19 Rona Road
London NW3 2HY

Basement Impact Assessment
Audit

For
London Borough of Camden

Project Number: 12066-75
Revision: F1

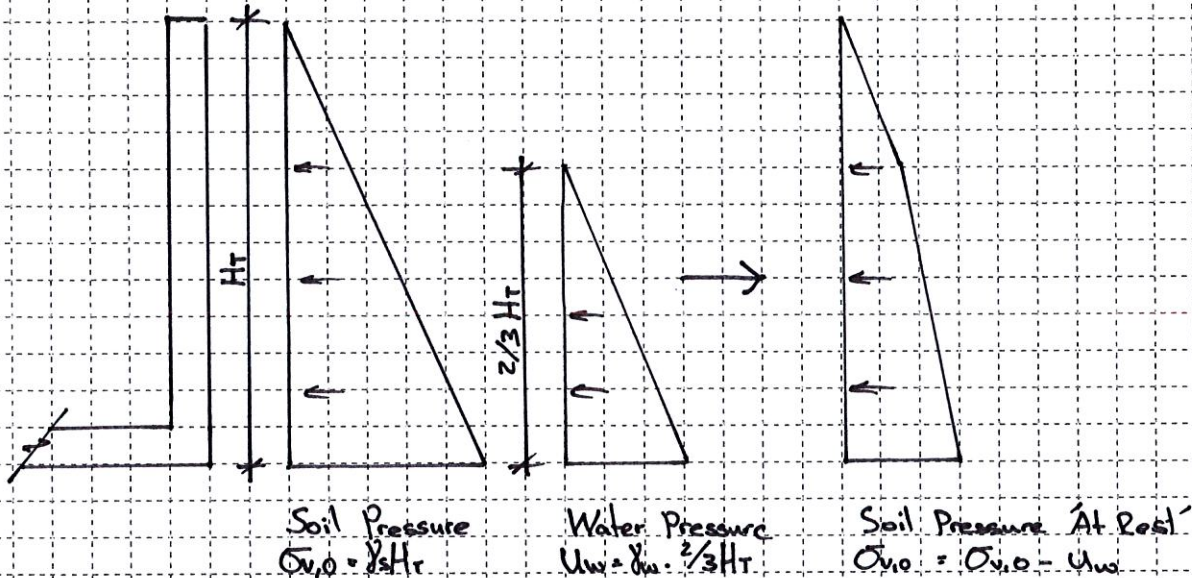
Soil Investigation

The borehole logs and test results were reviewed by:

He has commented as follows:

1. The logs indicate the presence of your 'typical' London Clay
2. Shear vanes indicate firm to stiff conditions with depth
3. shear vanes at the underside of the existing foundation indicate shear strengths of 80kN/m², assuming the shear vane equipment is calibrated to show a direct correlation with shear strength.
4. Given the ground conditions encountered, we would expect Nett Allowable Bearing Pressures for the London Clay at 1.8m to be in the region of 140 – 160kN/m²

Factor used for K₀

Clarification of K₀ and figures used in calculations previously submitted for water pressure as per appended sheet.

K₀ taken as 0.53 (to give the load of 8.77 kN/m² used in the calculations)
